## **Final Report - Corrections Required** **Application No. LUPL-25-0008**

**Document Filename : 241010\_BLR Village C Land Use Plan.pdf**

# BANNING LEWIS RANCH - VILLAGE C

BANNING LEWIS RANCH - VILLAGE C  
 LAND USE PLAN  
 COLORADO SPRINGS, CO  
 COVER SHEET

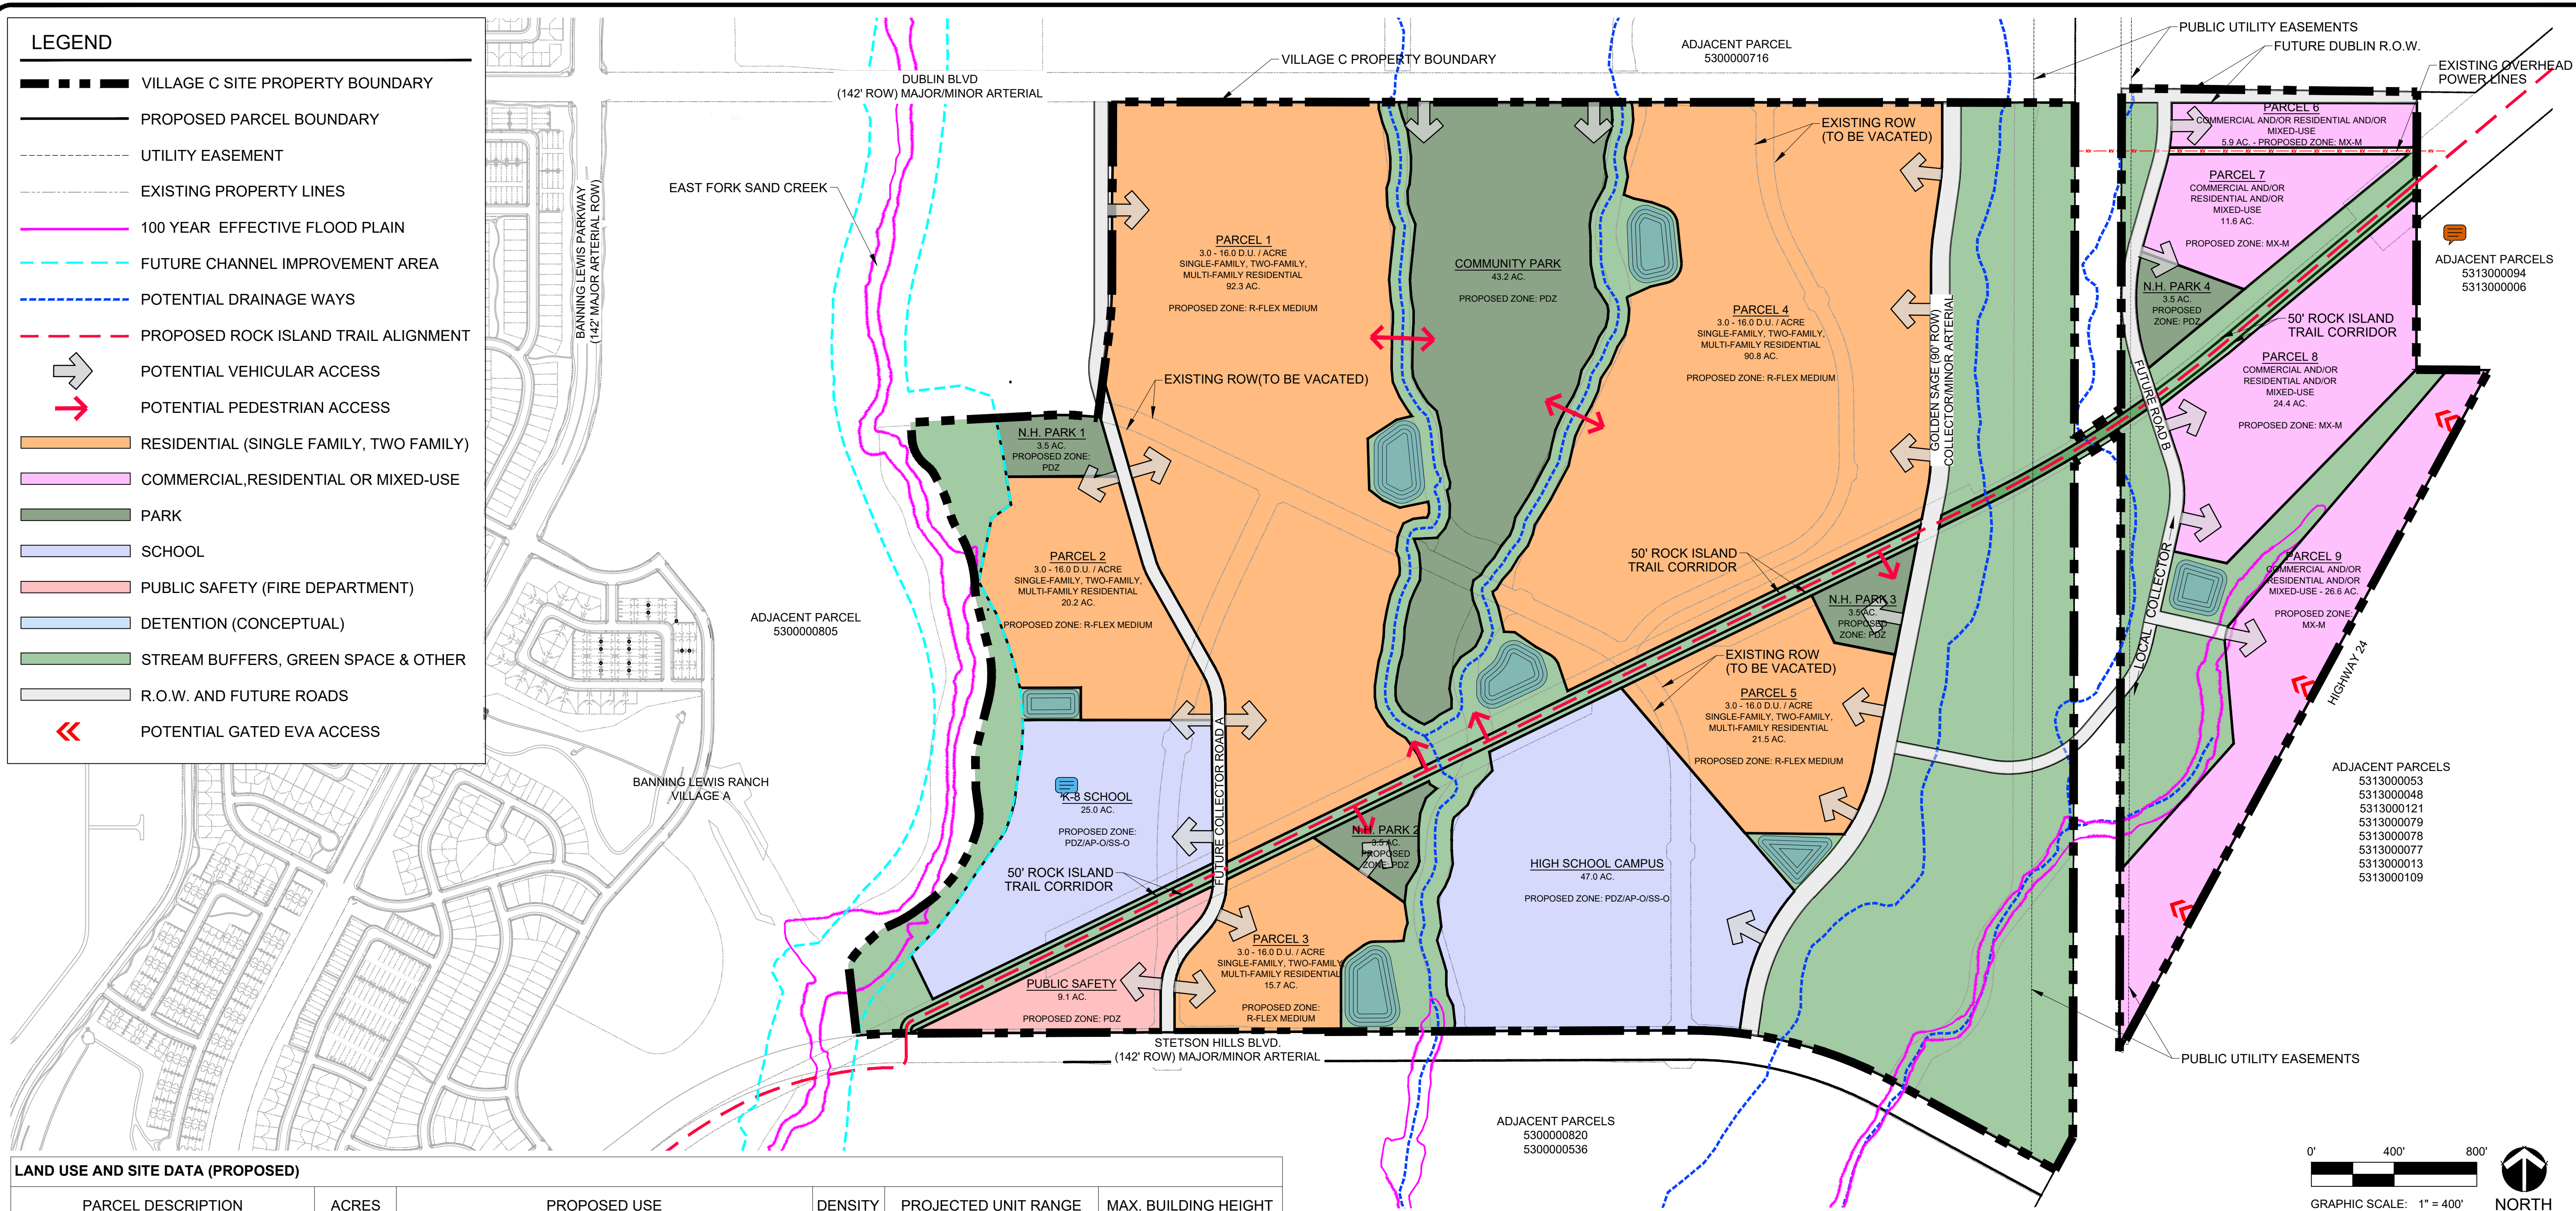
↑\*\*Springs Utilities comment to applicant: Springs Utilities comments will be provided at the time of the required Preliminary Utility and Public Facilities Plan submittal associated with the development plan entitlement.
